**TOWN OF MOUNTAIN VILLAGE
DESIGN REVIEW BOARD REGULAR MEETING
THURSDAY JANUARY 8 2015, 10:00 AM
2nd FLOOR CONFERENCE ROOM, MOUNTAIN VILLAGE TOWN HALL
455 MOUNTAIN VILLAGE BLVD, MOUNTAIN VILLAGE, COLORADO
AGENDA
(REVISED)**

**COMMUNITY DEVELOPMENT DEPARTMENT
PLANNING DIVISION**

Hotel Madeline
Phase 1 Remodel

Hotel Madeline
Phase 1 Remodel
Lighting Plan - Second
Level Pool

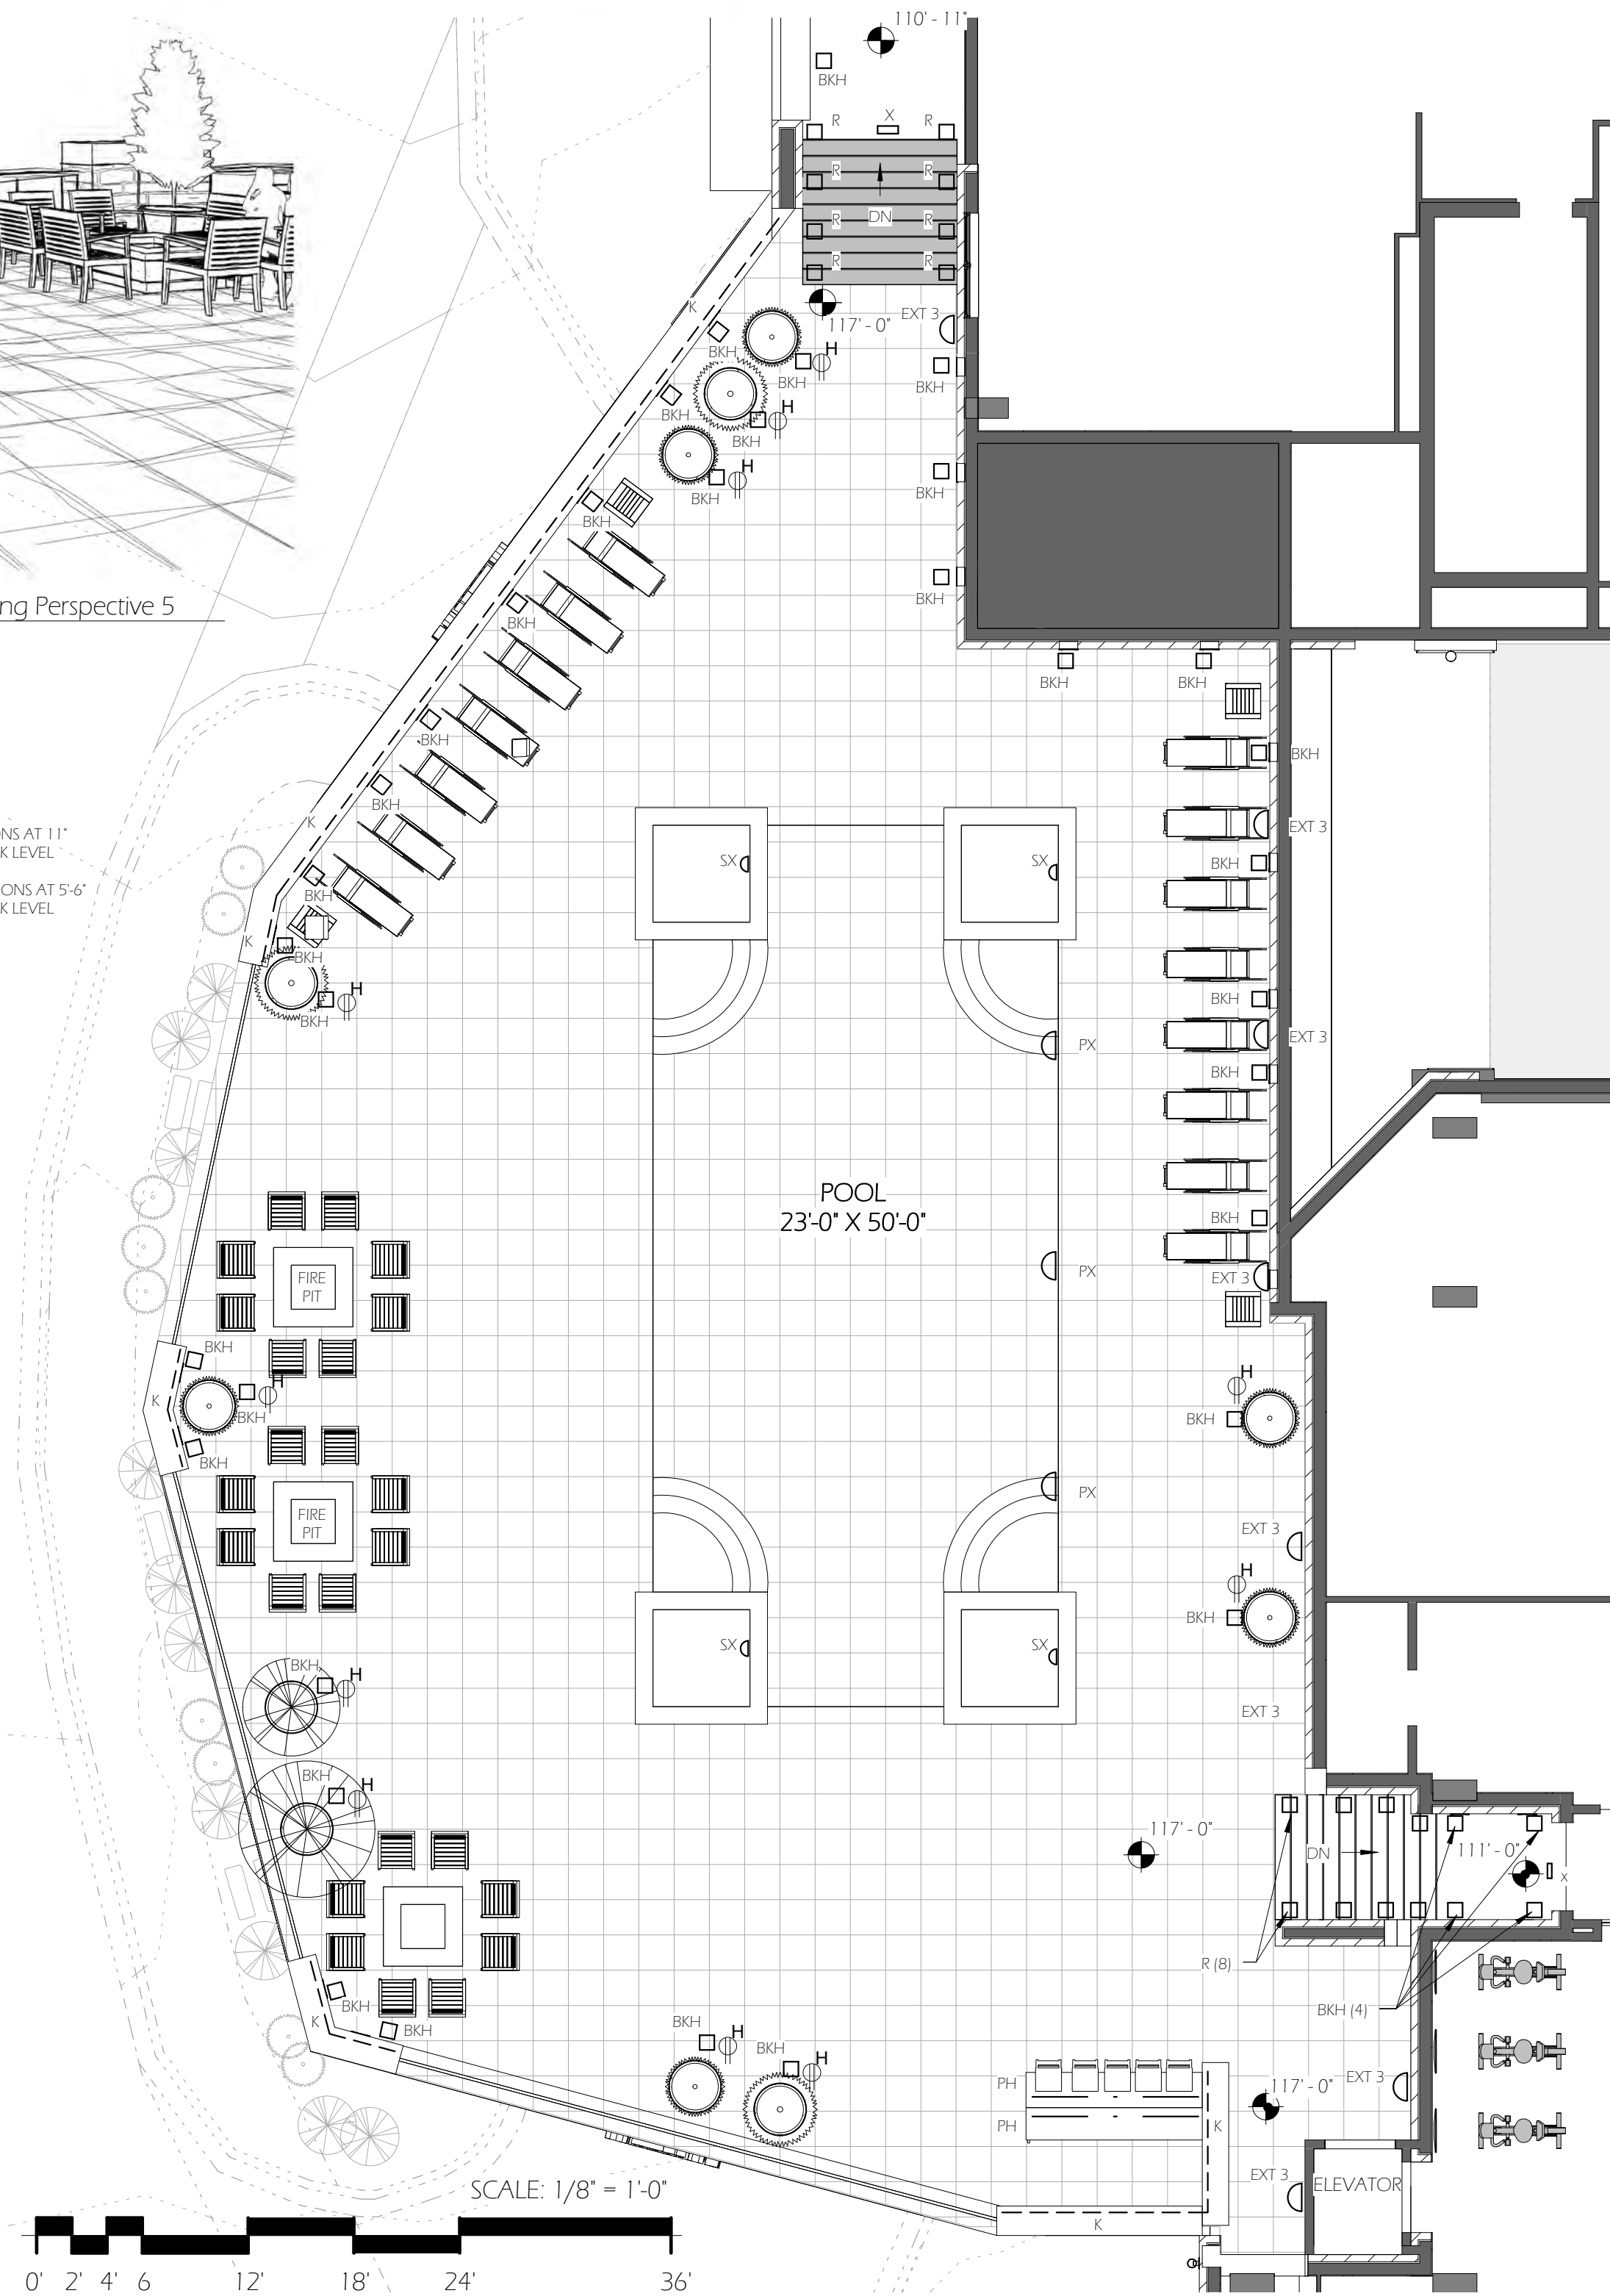
6. A lighting plan for porte cochere, pool deck and pool lighting shall be submitted in accordance with the Lighting Regulations for review and approval. *This condition has been met. Please refer to sheet A1.1.7 and A1.1.8 along with the associated lighting specification sheets. Staff has asked for clarification on the specifications for a few of the lights to ensure proper bulb temperature. The applicant's lighting designer will present the lighting plan at the meeting.*

Grading Plan

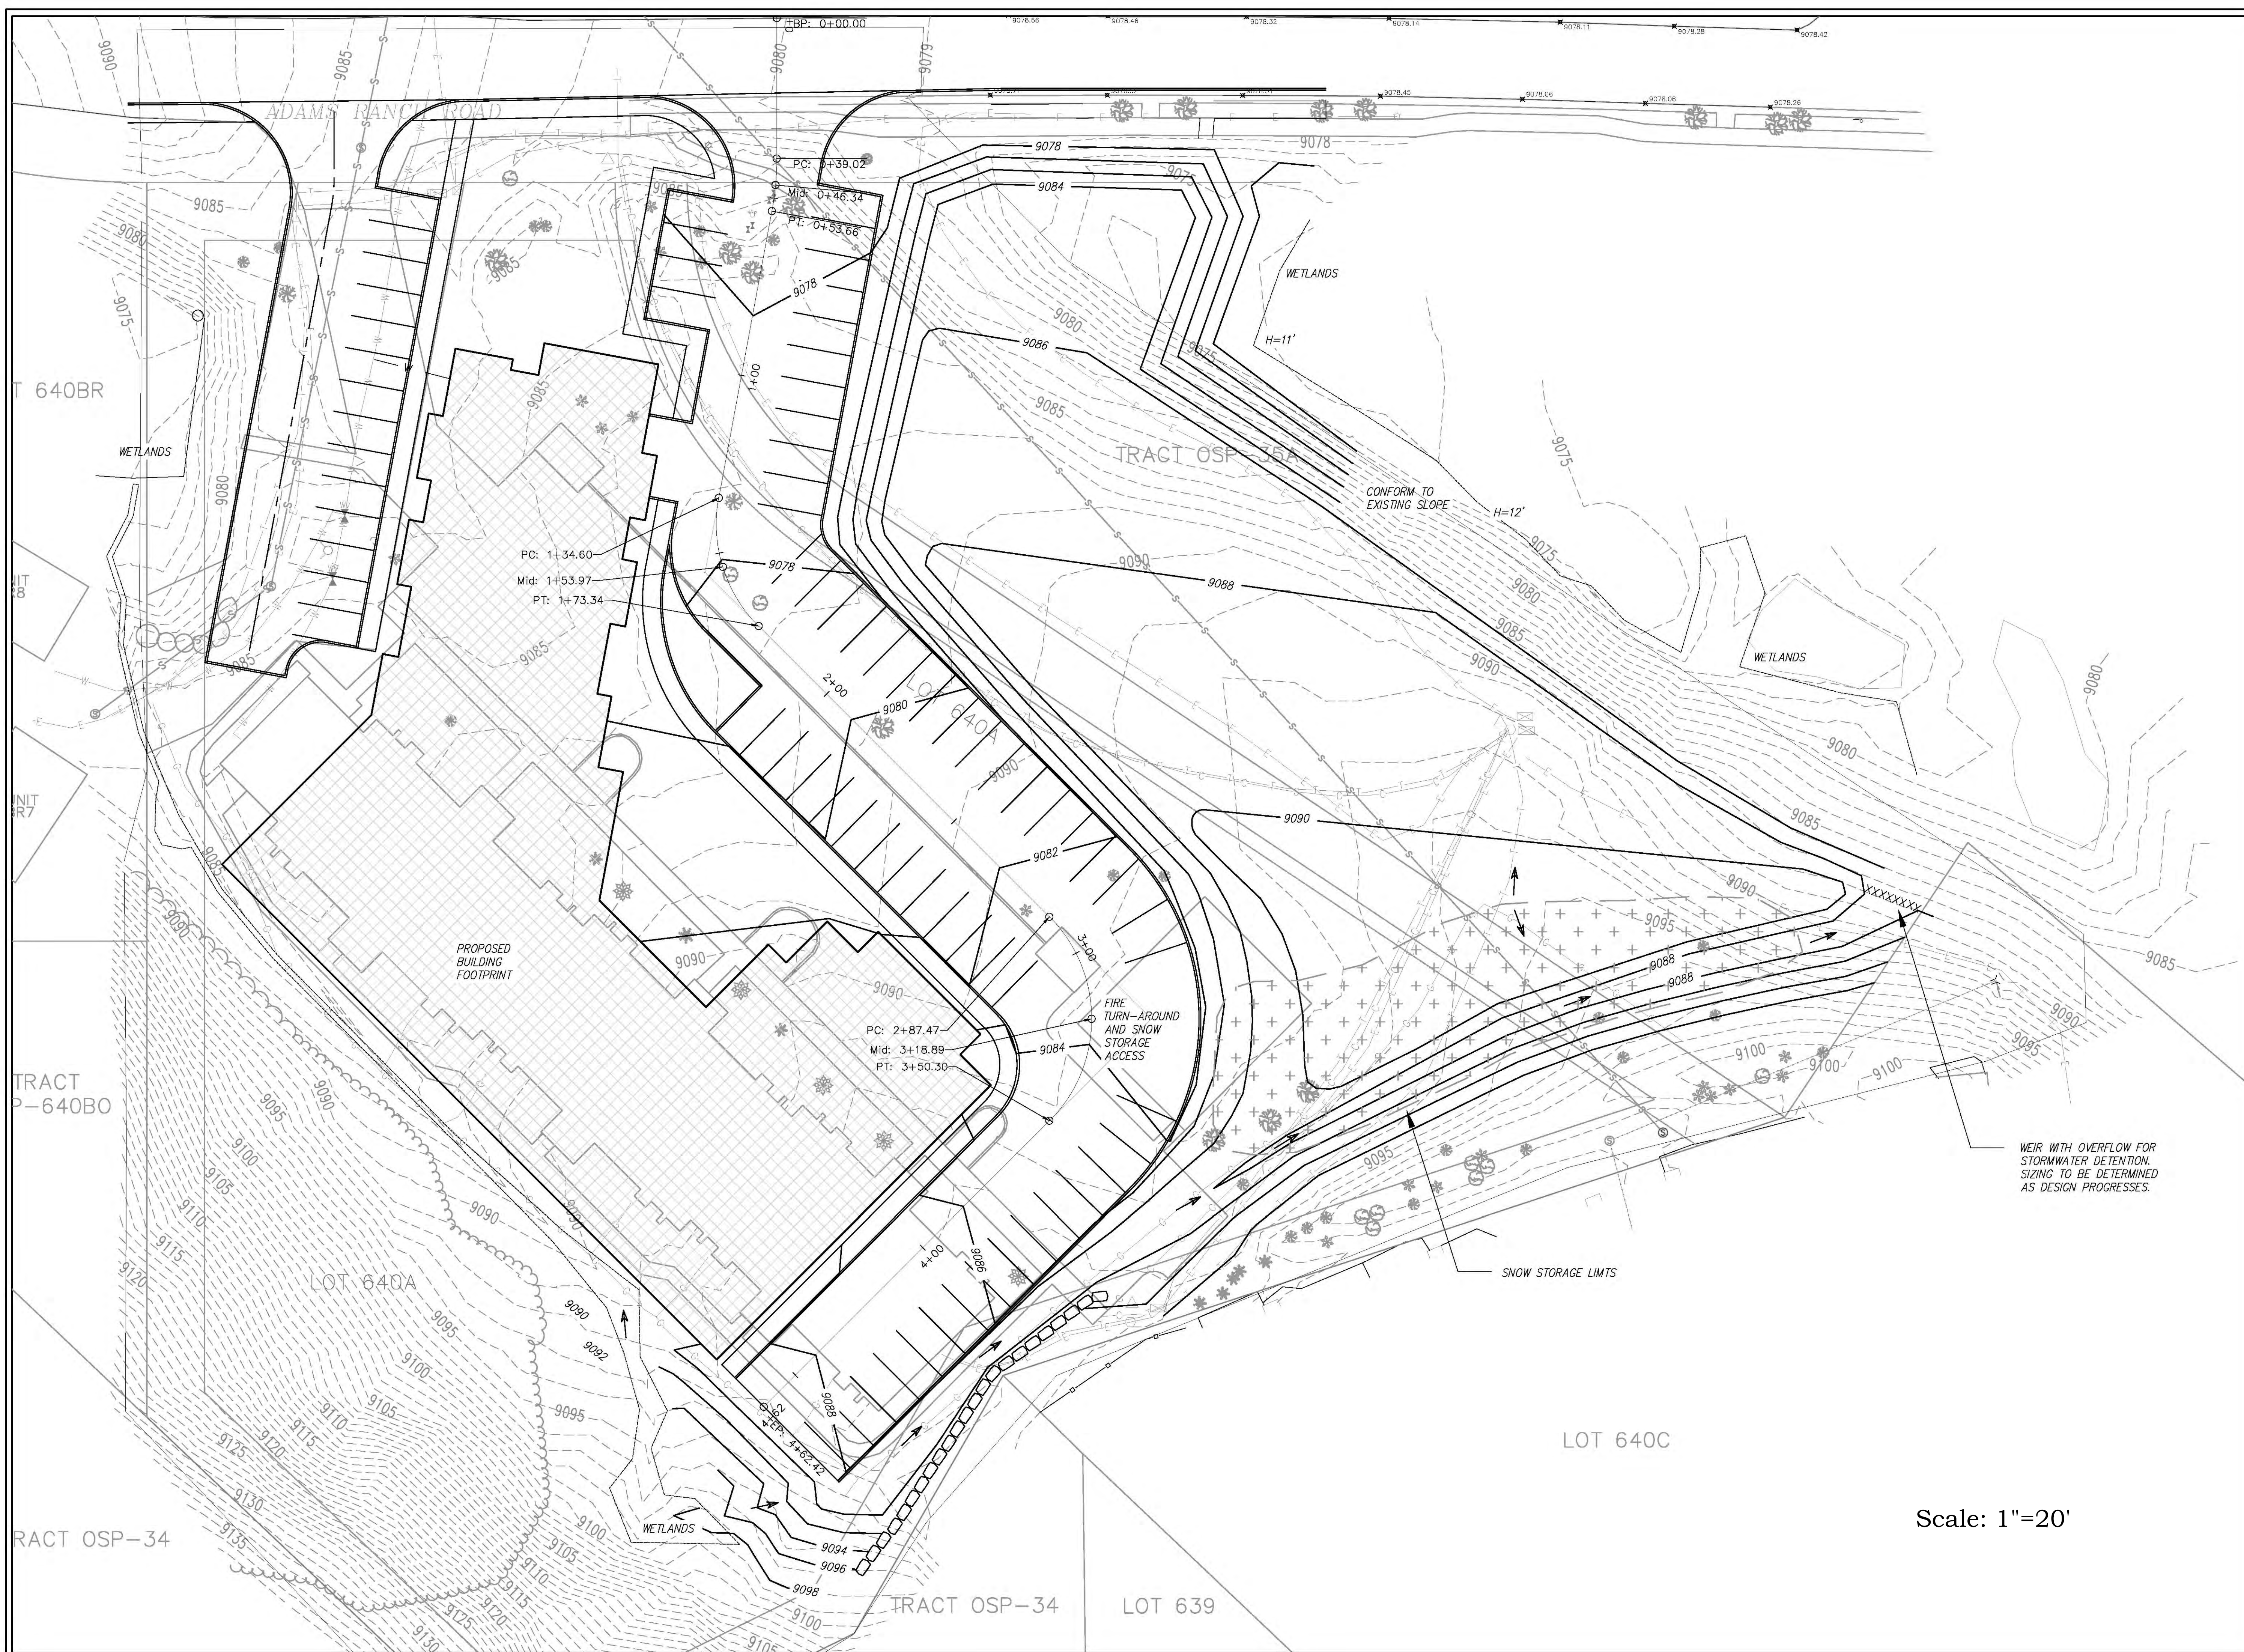
3. Civil engineering plans for the porte cochere improvements shall be submitted for review and approval. *This condition has been met. Please refer to sheet C.1. The sight distance triangle meets the requirements of the Road and Driveway Standards.*
